Commentary on the Town Centre Improvements proposed by Babergh DC and SCC Highways

15 August 2022

Market Hill, parking

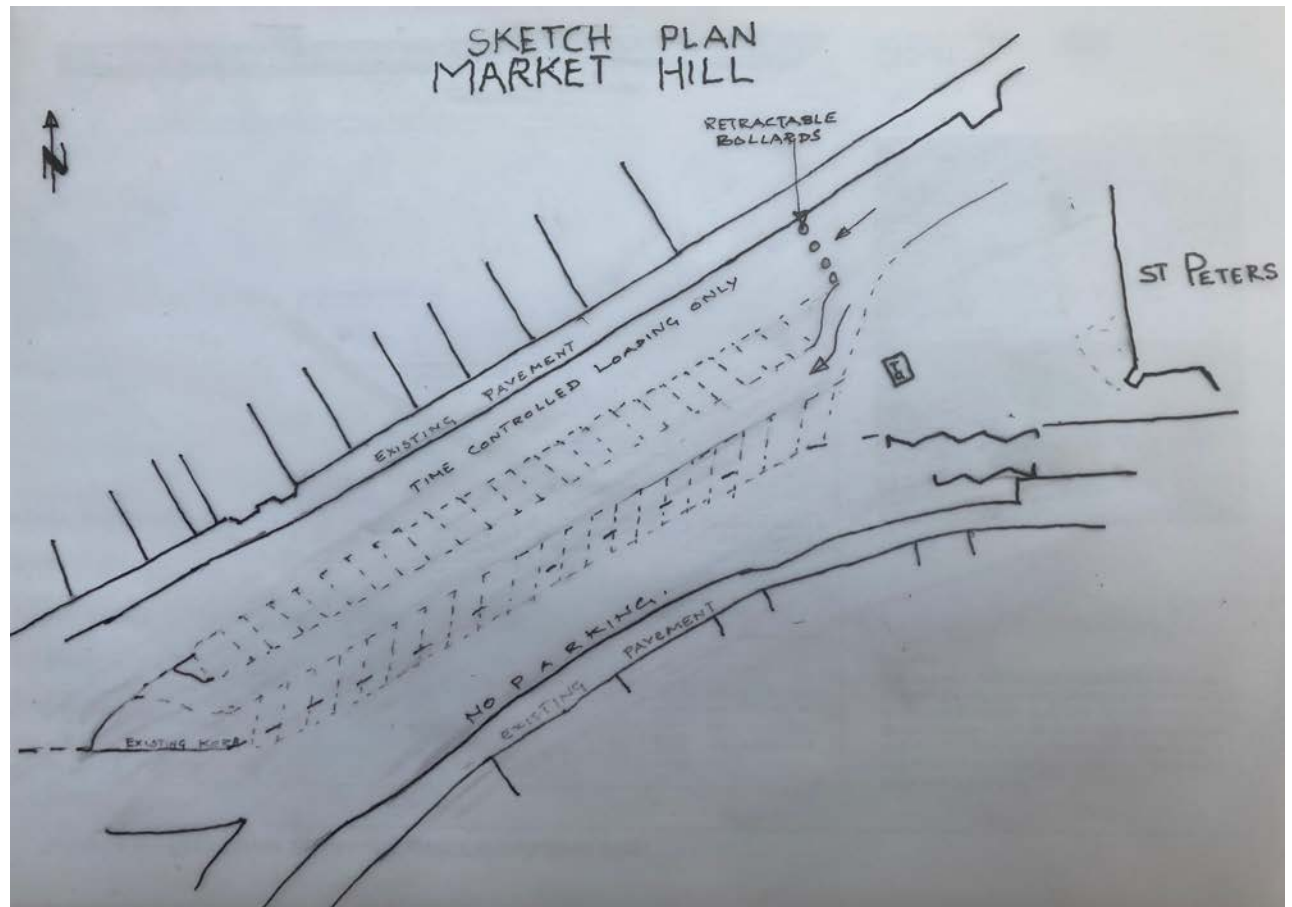
There are at present c.76 parking spaces on Market Hill, 42 in the central two rows, 17 on the north side and 17 on the south side. We welcome the proposals to reduce this but we oppose any drastic reductions which will do lasting damage to town centre trade.

The sketch shows how Market Hill could continue to accommodate two rows of parked vehicles (total 42) with an access road between them. At present, drivers entering and backing out from the outer row of spaces cause obstructions. In this sketch, traffic access to parking spaces is from behind St Peter's only.

The outer verge of the parking area would move southwards a few feet to accommodate this plan. This would require the removal of parking along Market Hill south side, retaining 7-8 spaces further to the south east on King Street, some of which can be for blue badge holders. The result will be total of c.50 spaces, a reduction by a third.

We advocate a semi-permanent 'high hedge' of planters with more substantial planting to separate parked cars from the A131 through road, with gaps between them for pedestrian access. Planters should contain non-seasonal taller shrubs to provide a screen against traffic noise and pollution.
